**Subject:** Request for Additional Information, dated May 2, 2001  
Sid Larkin & Son, Inc.  
Enterprise Class III Landfill, Pasco County  
Pending Permit Numbers 177982-001-SC and 177982-002-SO

On behalf of Sid Larkin & Son, Inc. (SLS), Hartman & Associates, Inc. (HAI) is submitting for your review, responses to the comments of your request for additional information, dated May 2, 2001, and our meeting on May 10, 2001 for the above referenced facility. Your comments are stated first with our responses following.

**GEOLOGIC CROSS SECTION A - A'**  
**PROPOSED ENTERPRISE RECYCLING AND DISPOSAL FACILITY**  
**DADE CITY, FLORIDA**

**FIGURE 6.2**

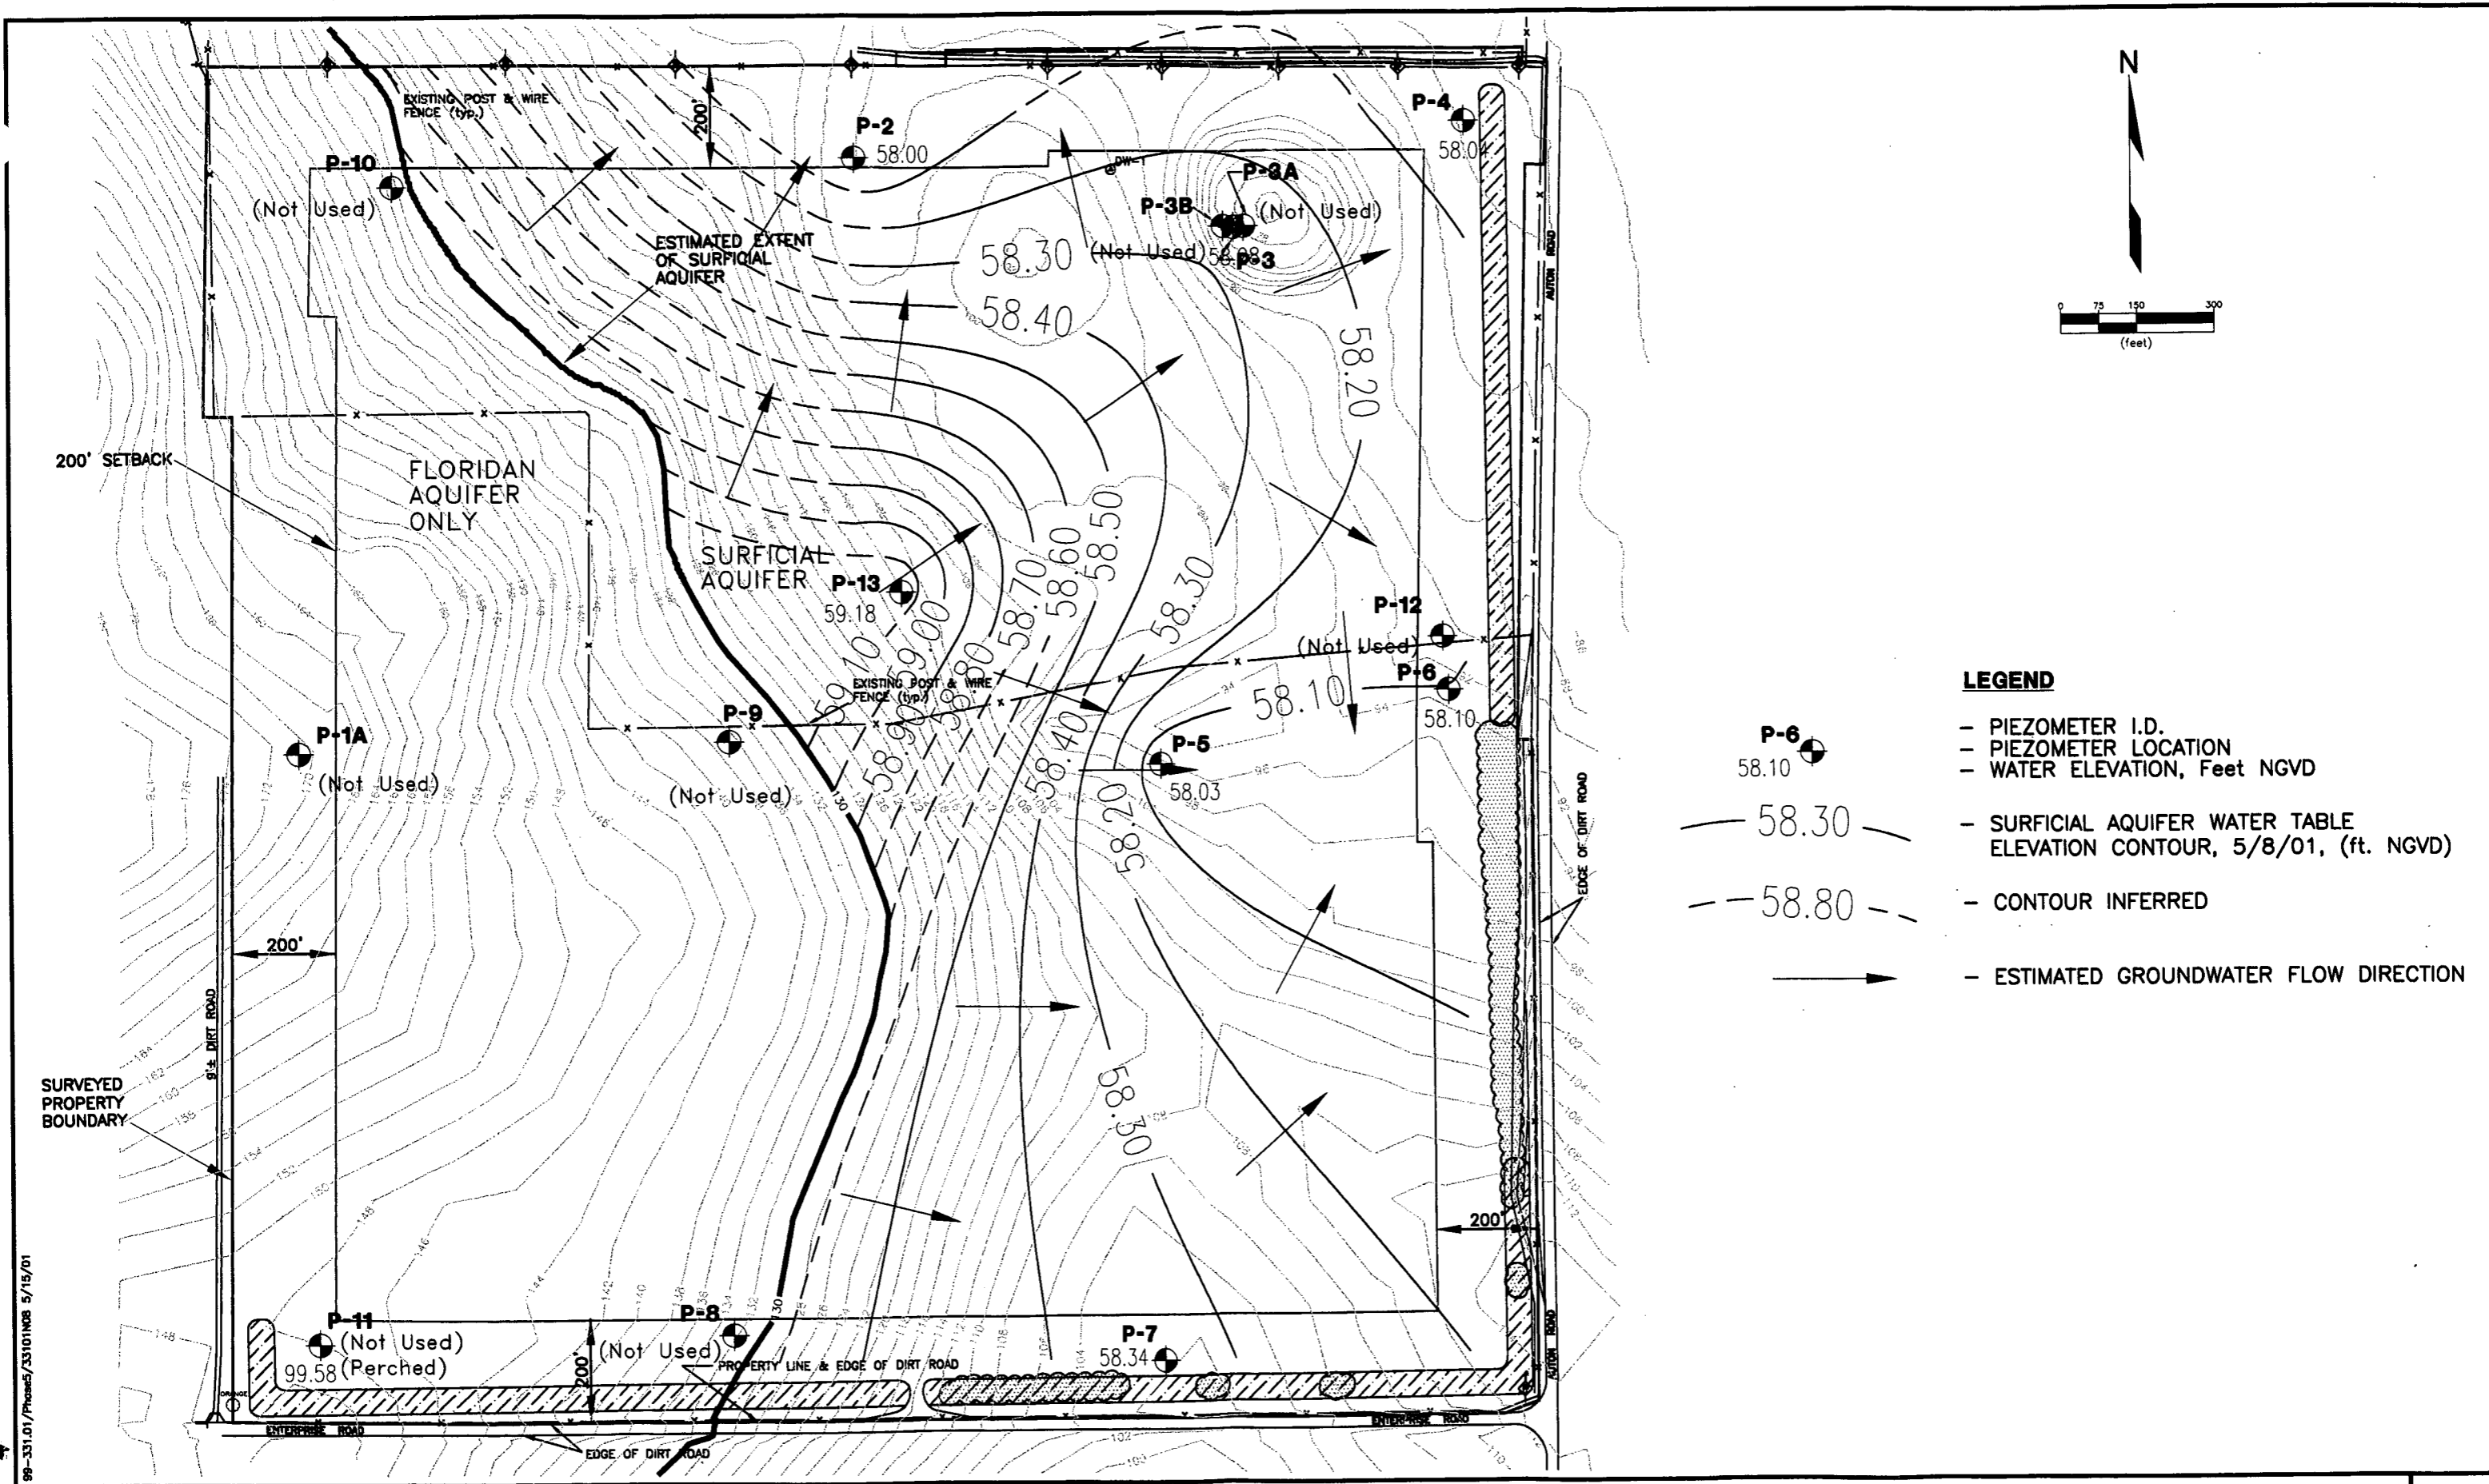
**Comment iii.** Figure 6.2 appears to indicate the elevation of the screened interval at P-10 ranges from about 54 to 64 feet, while the well completion log appears to indicate the elevation of the screened interval at this location ranges from about 60 to 70 feet. Please review and revise as appropriate. (Submittal 2)

**Comment v.** Figure 6.2 appears to indicate the elevation of the screened interval at P-11 ranges from about 70 to 80 feet, while the well completion log appears to indicate the elevation of the screened interval at this location ranges from about 88 to 98 feet. Please review and revise as appropriate (Submittal 2)

Comment ix: Figure 6.2 – Please revise this cross section as appropriate to address review comments Nos. 3.b.ii. through 3.b.v., above (Submittal 2)

**Response:** Figure 6.2 cross-section and the well completion log for piezometer P-10 are consistent. The figure shows P-10 with a screened interval from 54 to 64 ft NGVD; while the well log shows a screened interval from 65 ft to 75 ft below grade (at 129 ft NGVD) or a screen from 54 to 64 feet NGVD.

**Response:** Figure 6.2 has been revised to more accurately depict the screened interval of P-11, see attached.

**Response:** Figure 6.2 has been revised to depict the revisions addressed by these comments, see attached.

FIGURE  
3-24

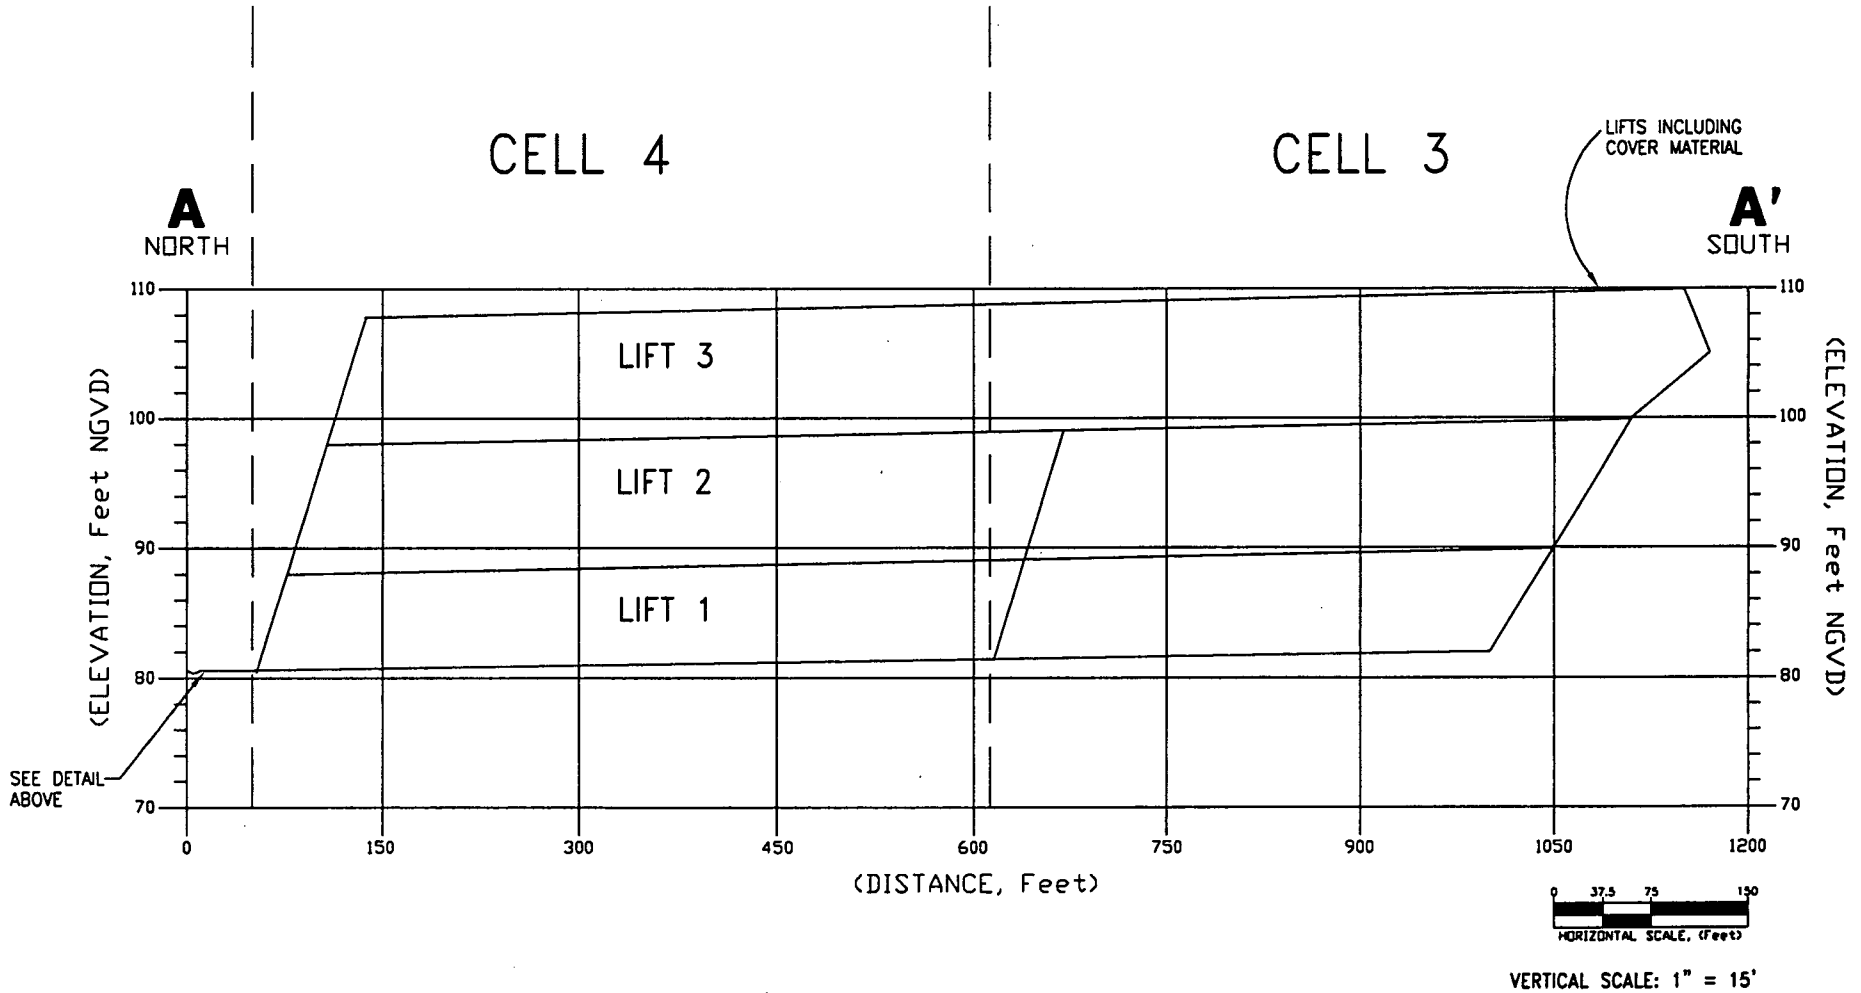
**Comment 3.** 62-701.330(4)(d). (1.) Grades to drain each intermediately covered lift to prevent ponding of stormwater over filled portions of the site are requested for Sequences 1 and 2. These grades may be shown on the Figures 3-24 through 3-27. Details to show the design and location of the Cell 1 temporary access road from the scale to the initial working face. All figures and cross-sections related to the sequence of filling for Sequences 1 and 2 should be included as part of the operation plan.

**Response:** Figures 3-24 through 3-27 have been revised to show grading of the lifts to prevent ponding of stormwater over the filled portions of the cells. Additionally, these figures have been added to the Operations Plan as Appendix G. Please see the attached figures.

1. Lifts will be graded slightly to promote stormwater runoff to the swale.
2. Lift grading shown is approximate.
